Site Plan

Preliminary Perspective Sketch

PROPOSED THIRD FLOOR
1"=20'0"

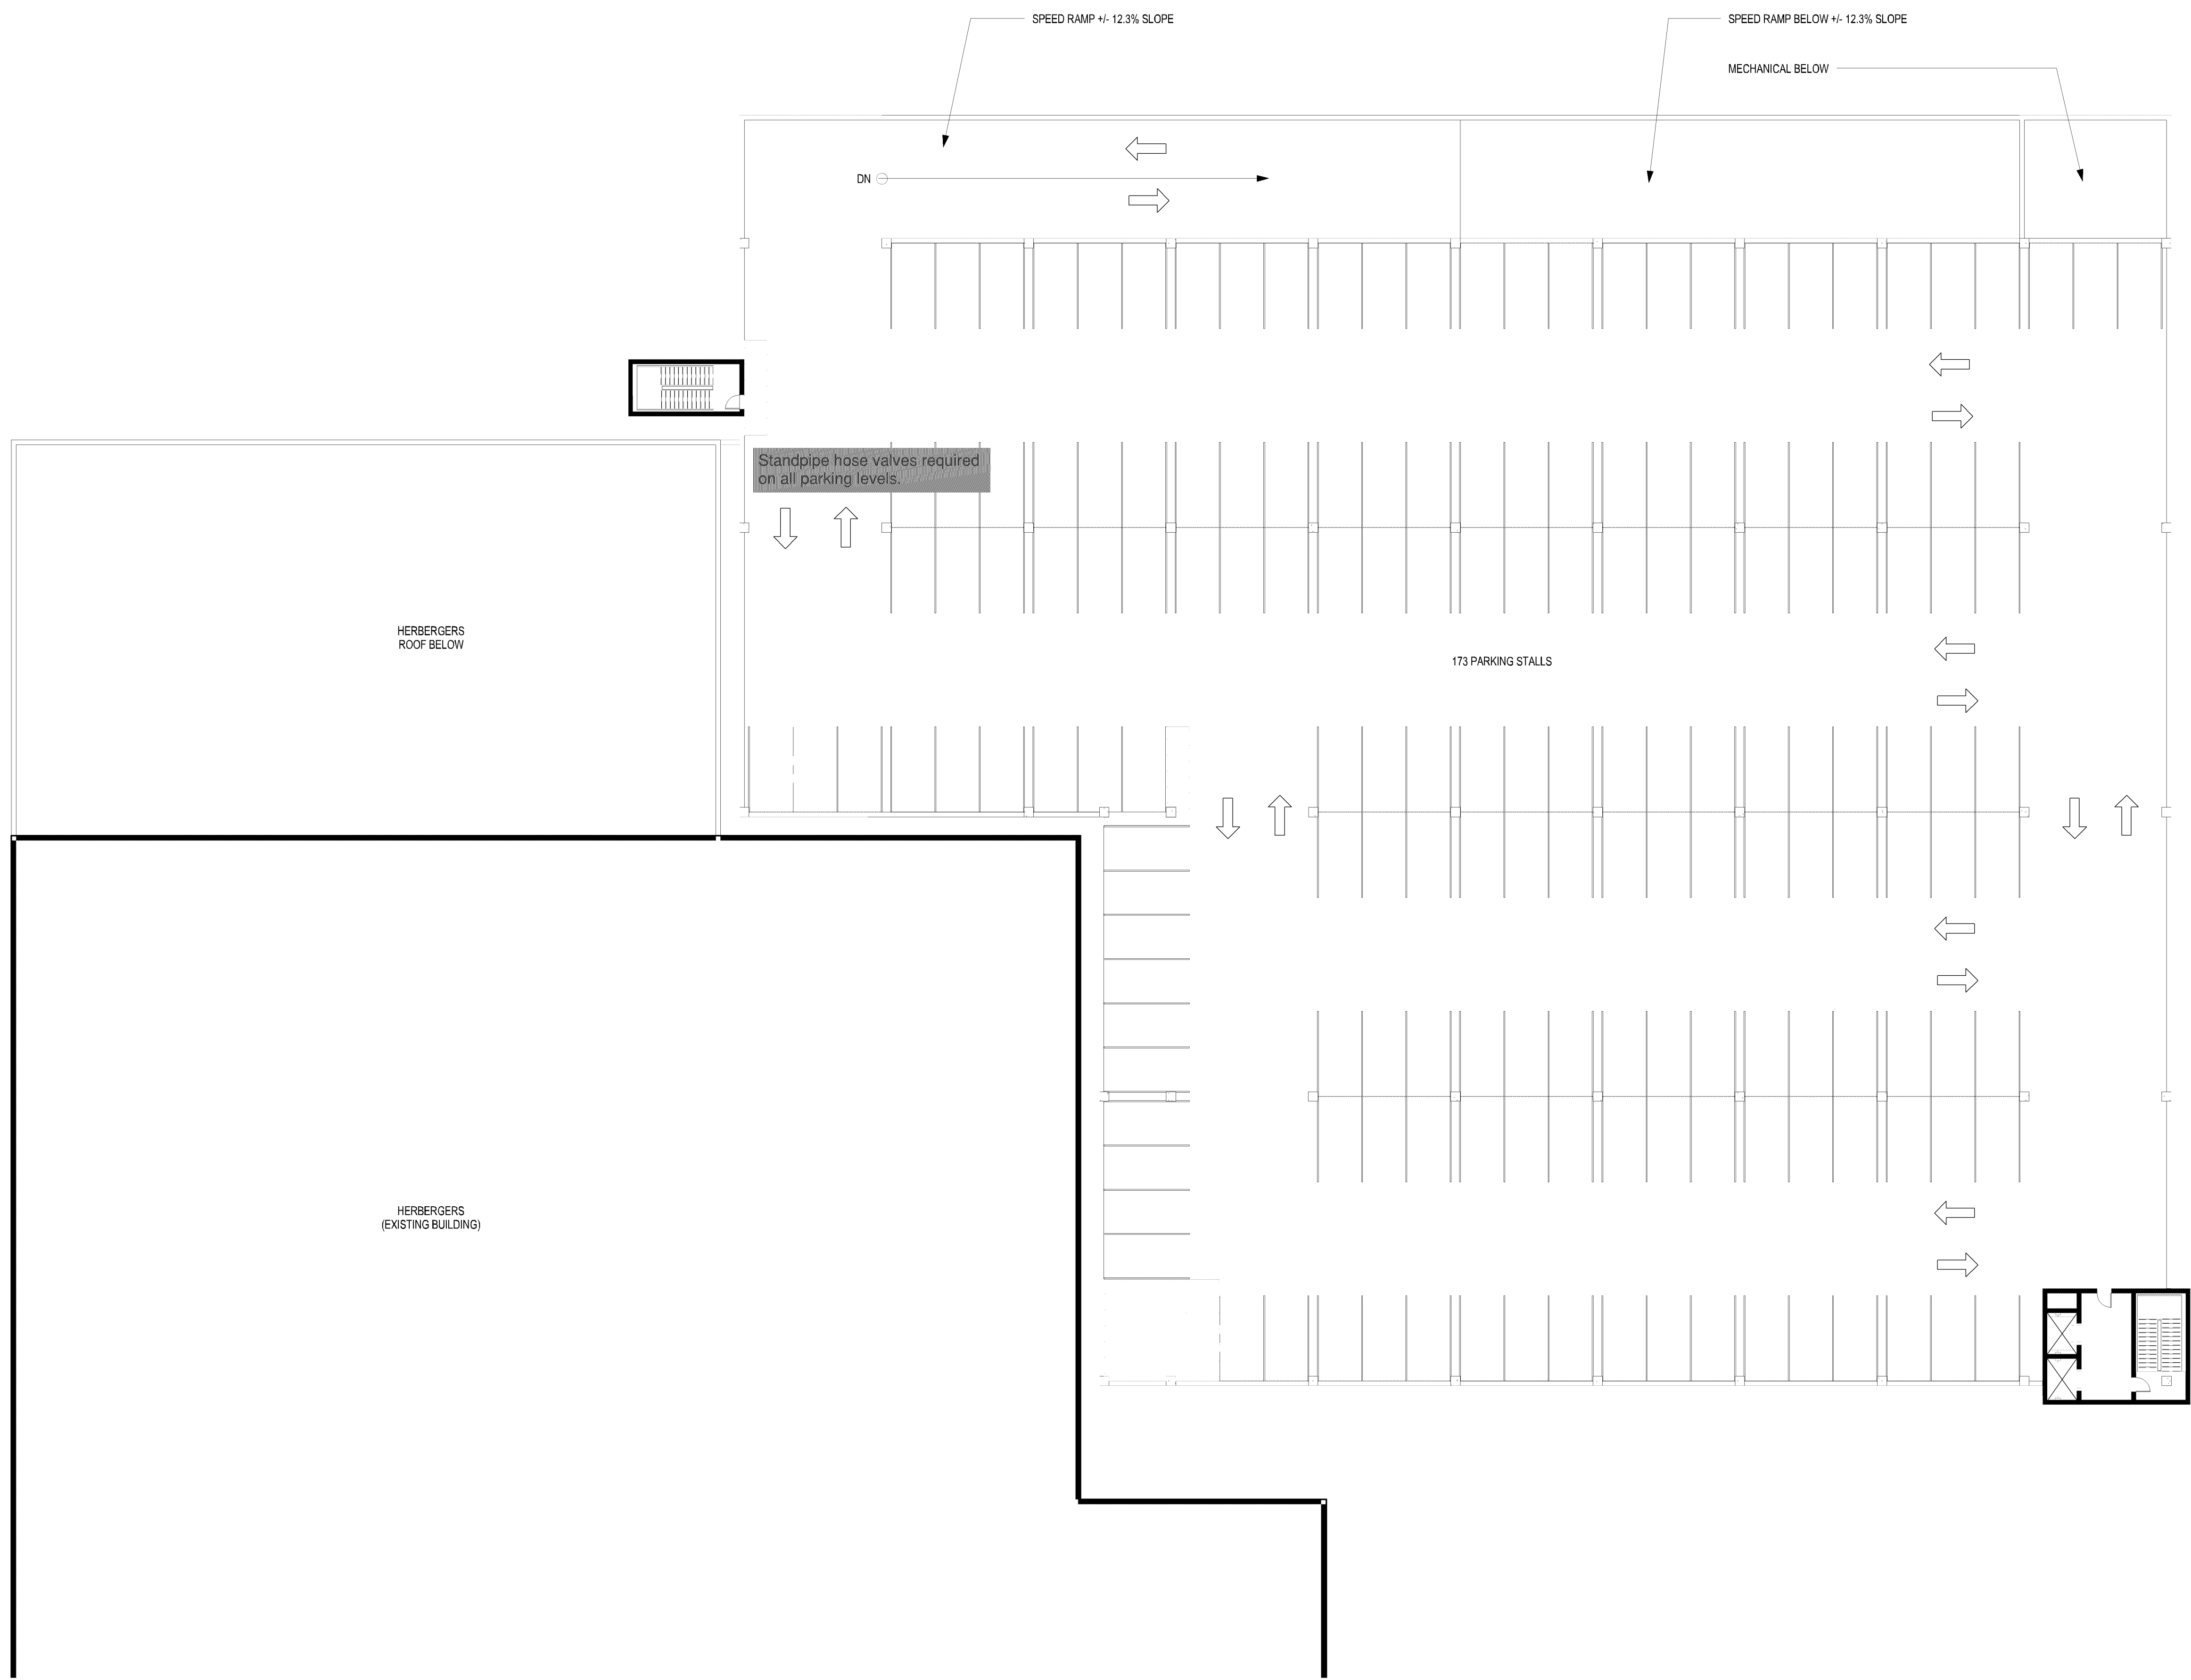
Signage is not permitted above building roof lines or on parking structures. The elevator shaft may be a good option for elevated signage.

The Southtown Shopping Center uniform sign design is in need of an overhaul. This project affords the opportunity to review the signage plan for the entire shopping center.
